# Chesterfield Station HS2 Masterplan

Consultation Report & Designer's Response

Project Number: 60633229

April 2021

**Figure 5.1:** Chesterfield Cycle Campaign Proposed Cycle Routes

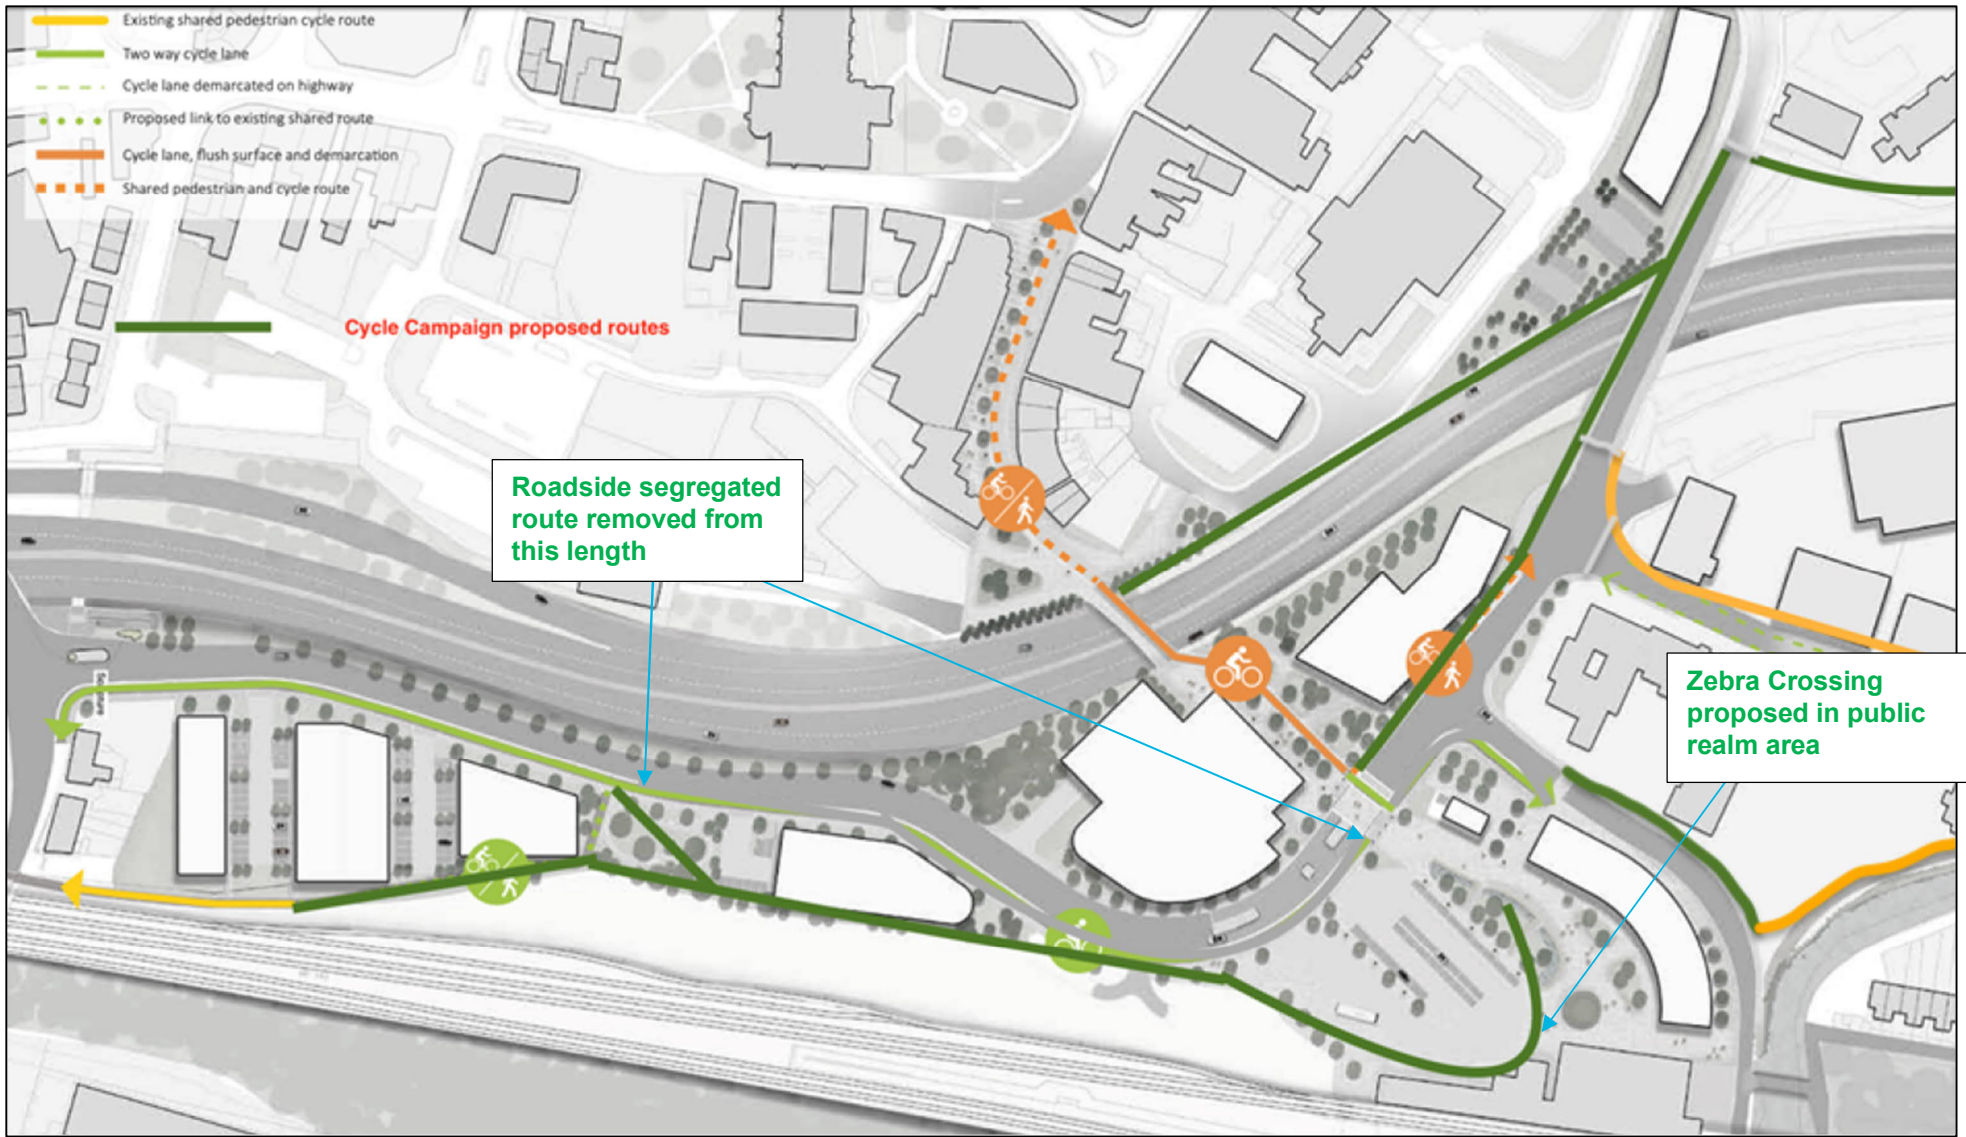
5.15.5 Figure 5.1 shows the alternative scheme proposed by CCC.

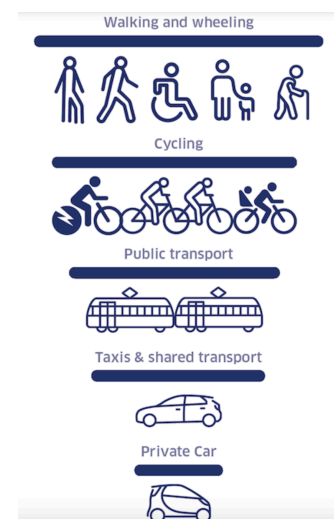
The current segregated cycle/footway that runs from the A61 bridge to the Brewery St Toucan is not shown on any of the drawings. This link needs to be retained and enhanced.

Fig 2 Station forecourt detail

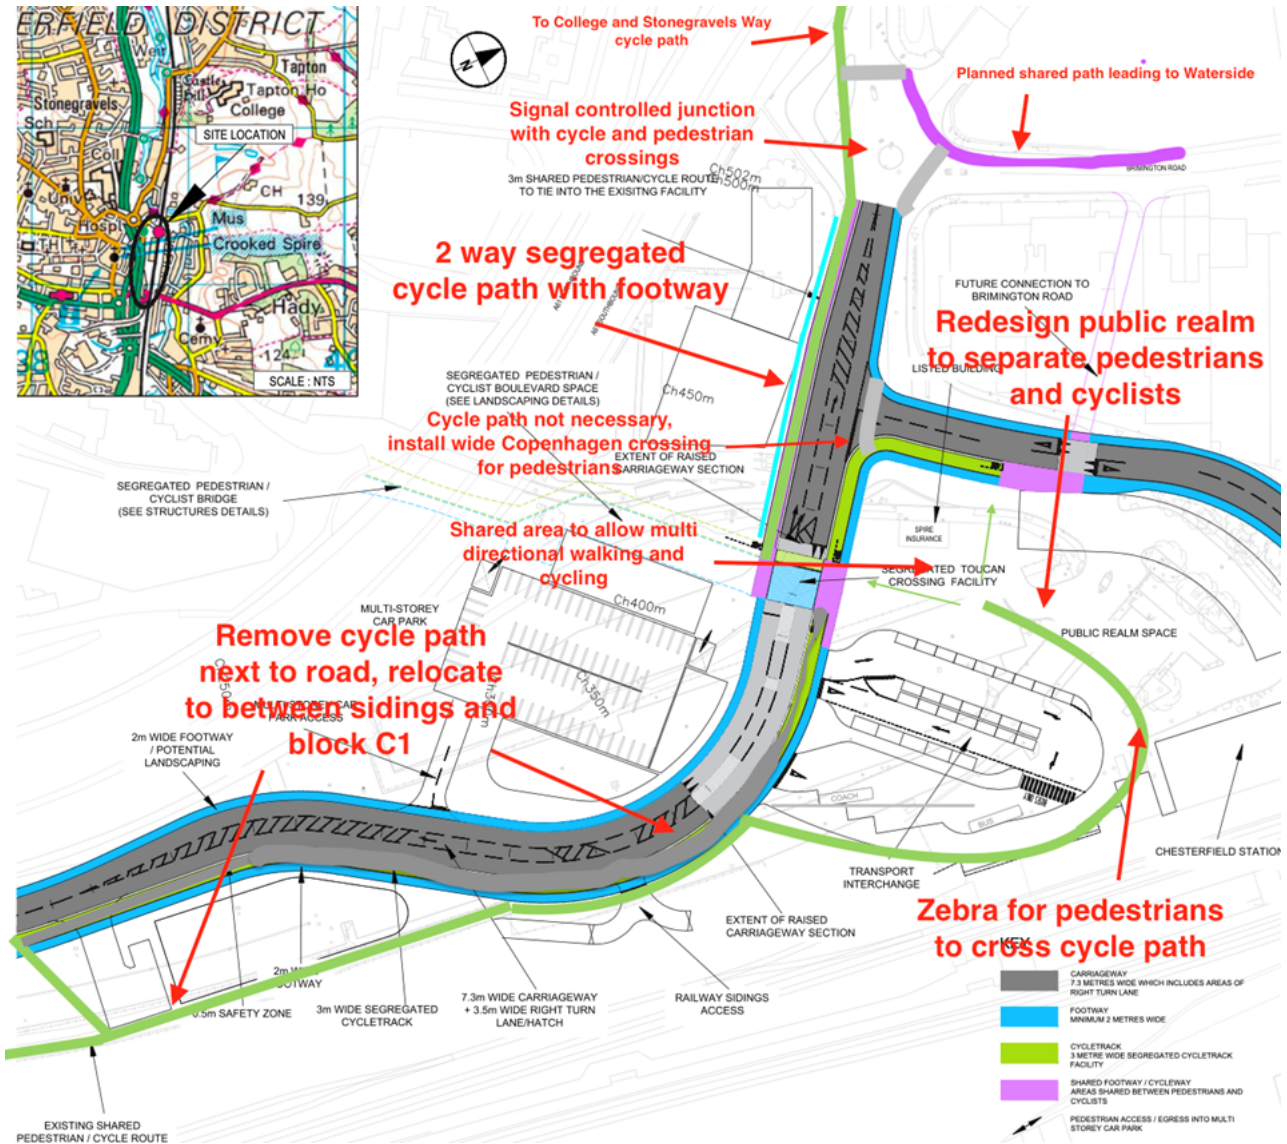
We have included two plans modified from those shown in the masterplan to illustrate the issues described above. Fig 2 shows the forecourt area in more detail with our amendments.
